INFORMATION NOTE

N° 051/19

Change of mold cavity affecting IAUA200N04S5N010, IAUA180N04S5N012, IAUA120N04S5N014 for PG-HSOF-5

Gate position

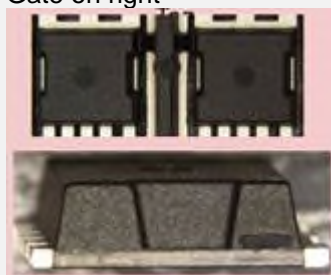
Subject: Relocate Mold Gate position

Reason: Process Improvement and assure of supply stability

■ Gate on right

■ Shifted Gate on left side

POD will not change only mold gate position
Gate is visible on outside package
